SANTAQUIN CITY CORPORATION

PLANNING COMMISSION MINUTES

**Preliminary Plan Review
of
Carriage Towne Meadows**

(JOHNNY JOHNSON BUILDING LOTS, LAYOUT)

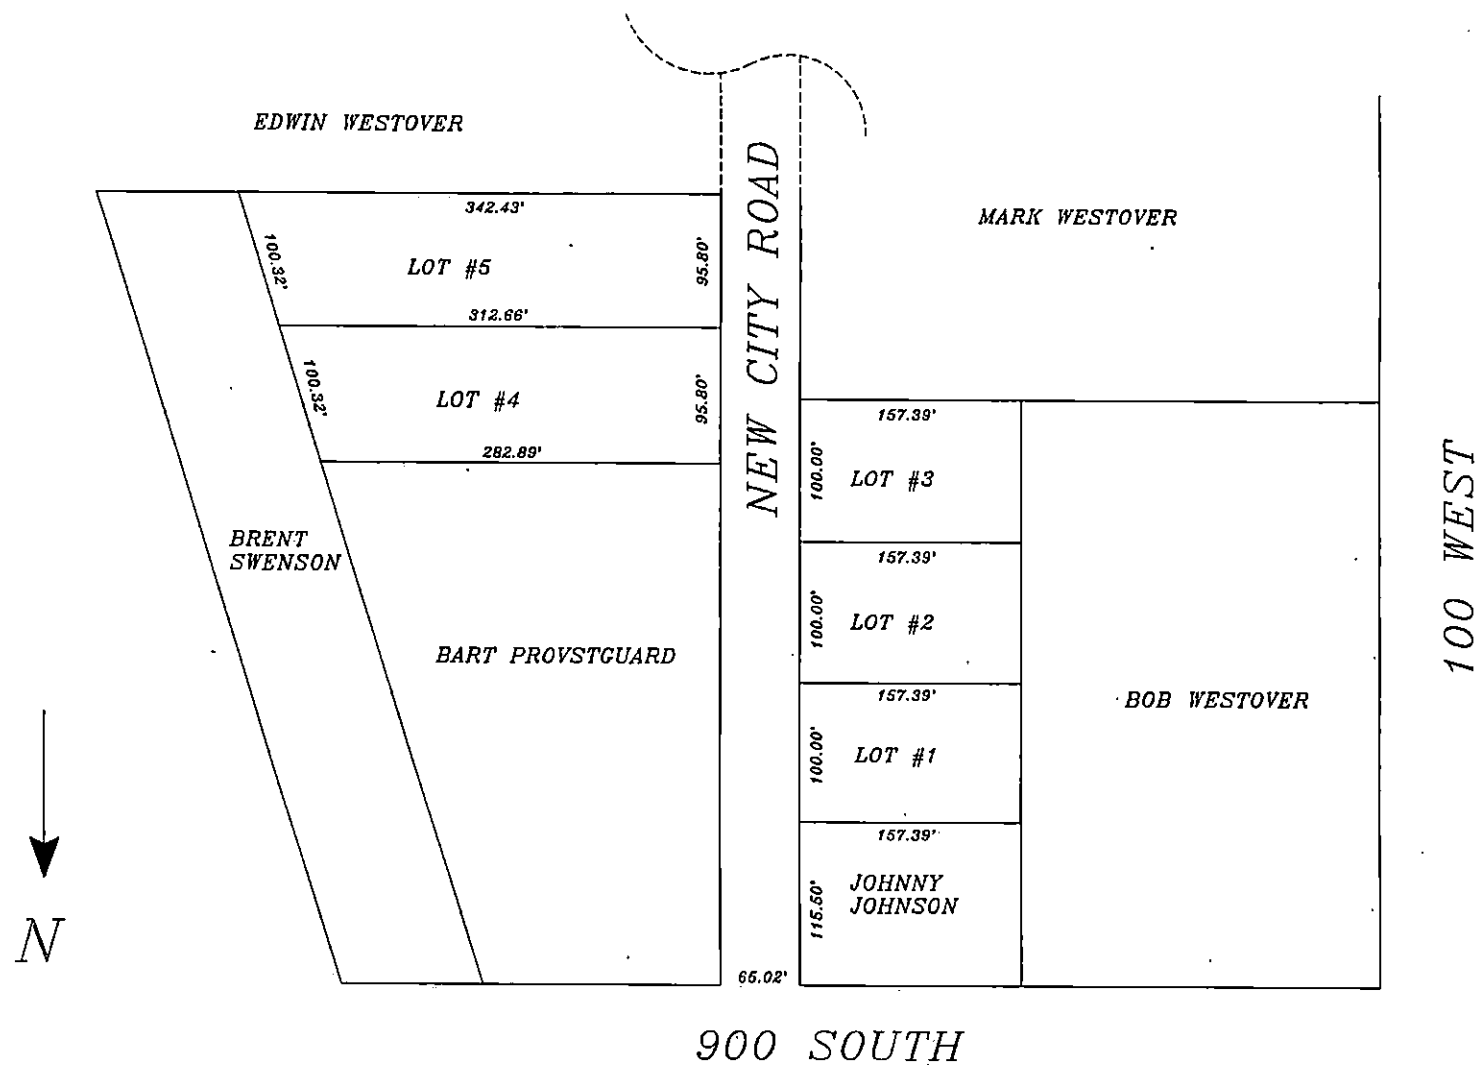
Shawna pointed out error on road: says 65.02'; should be 56.02'.

There was a discussion about a turn around for future road. Brent said old Ordinance states there can be no deadend streets; must end in cul-de-sac, 100' radius, asphalt.

There was a question on required setback for existing Provstgaard's home and proposed location of road.

Mr. Sowby related some of Mr. Berg's concerns: temporary turn around; review previous approvals on the Westover piece, whatever has been approved there, it needs to conform with that; whether curb and gutter will be required on both sides; if house exists, you can't create a problem there, you have to be the 30', so the road would have to slide over.

Questions that need to be answered: turnaround, curb and gutter location, is sidewalk required, what is setback

for Bart Provstgaard's house with regard to new road, will they need to run sewer.
